Project Submittal Interim Form

Intersection of US 401 at SR 2044 (Ligon Mill Road) and SR 2224 (Mitchell Mill Road) (U-5748 Central)

Subject: **Modification Request for Section 404 Regional General Permit 50, Section 401 Water Quality Certification and Neuse Riparian Buffer Authorization** for Upgrade of an Existing at-grade Intersection of US 401 at SR 2044 (Ligon Mill Road) and SR 2224 (Mitchell Mill Road) to offset Continuous Flow Intersection from the US 401 and Leland Avenue Intersection to the US 401 and Perry Creek Road Intersection in Wake County; TIP Number U-5748. Debit \$570 from WBS Element 50168.1.1.

BUFFER DRAWING
SHEET 5 OF 9
REVISED AUGUST 2022

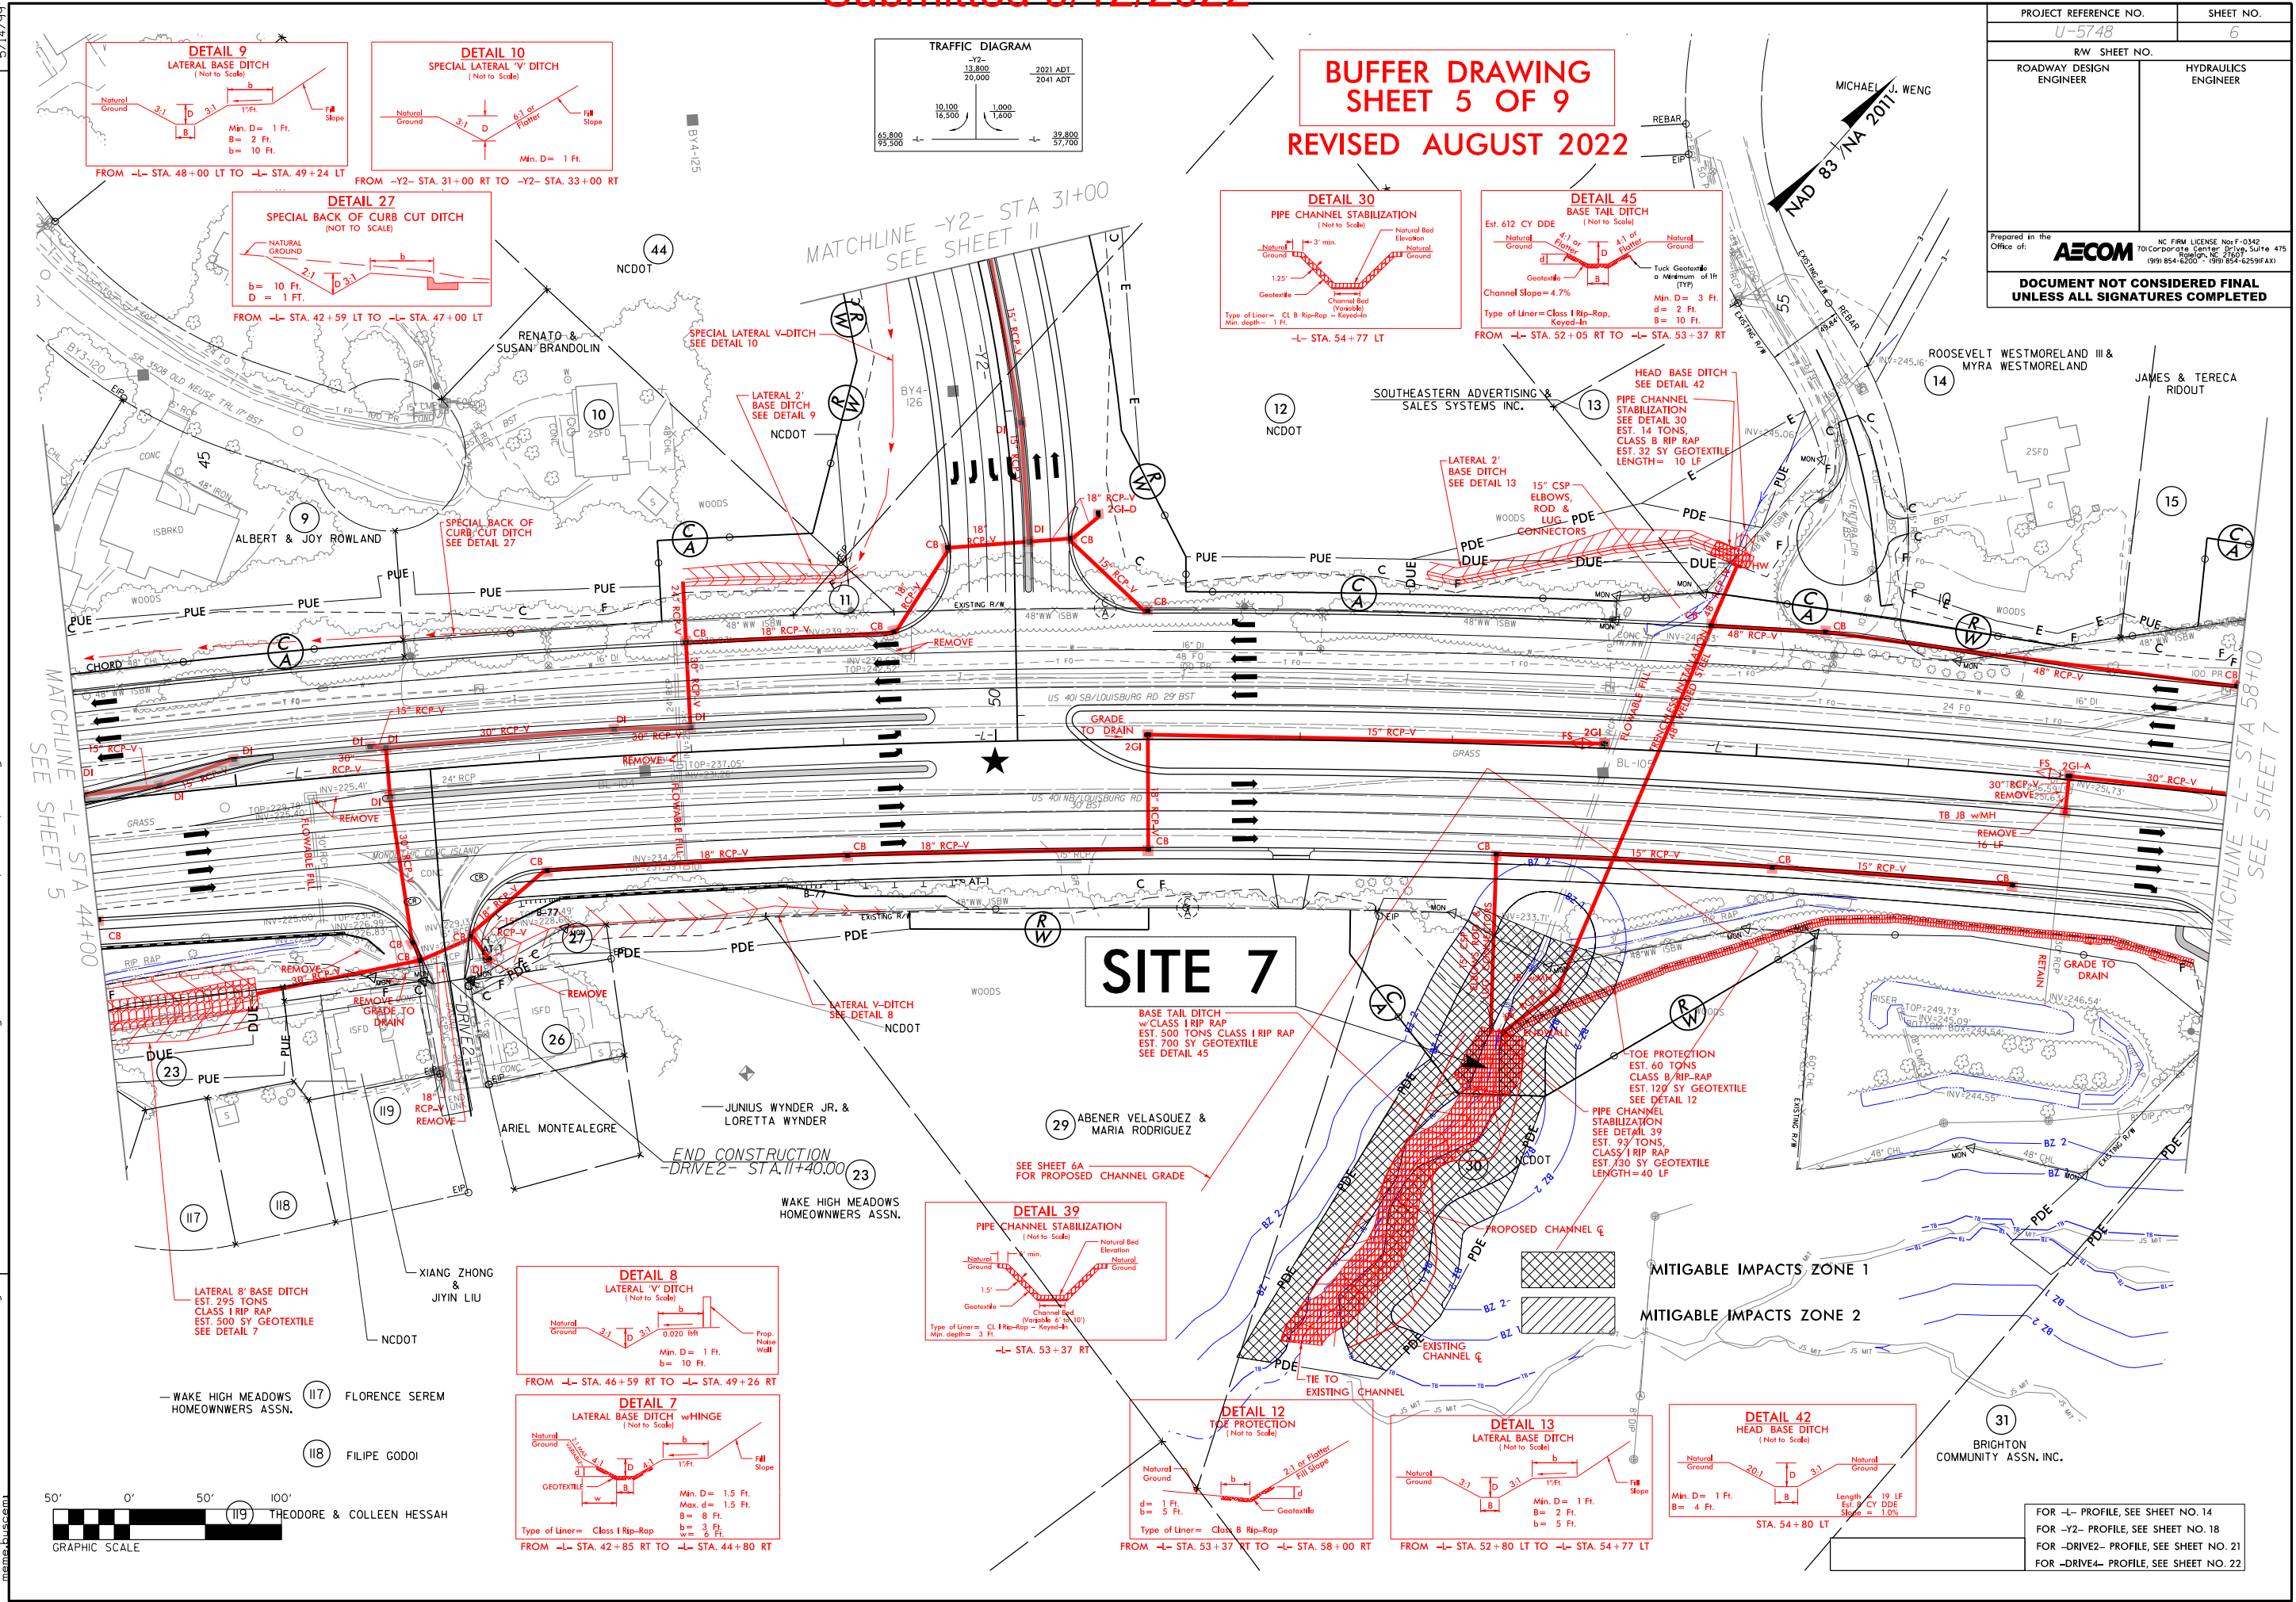
Site 7: Due to constructability concerns, a drainage design revision was required to delete a deep drainage inlet. This revision removed the pipe outlet at Site 13 and instead, directs the water to outlet at Site 7. Due to the poor existing conditions of the channel at Site 7 and the proposed increase in drainage to this area, rip rap channel stabilization is proposed to be added for the length of the degraded channel section. This will result in the following changes:

- 213 linear feet increase in permanent stream impacts
- 14 linear feet increase in temporary stream impacts
- Increase of 12,526 sq ft Buffer Zone 1 impacts
- Increase of 2,541 sq ft Buffer Zone 2 impacts

Site 13: Due to constructability concerns, a drainage design revision was required to delete a deep drainage inlet. This revision removed the pipe outlet at Site 13 and instead, directs the water to outlet at Site 7. This will result in the following changes:

- 20 linear feet decrease in bank stabilization impacts
- 29 linear feet decrease in temporary stream impacts
- Decrease of 1,876 sq ft Buffer Zone 1 impacts
- Decrease of 792 sq ft Buffer Zone 2 impacts
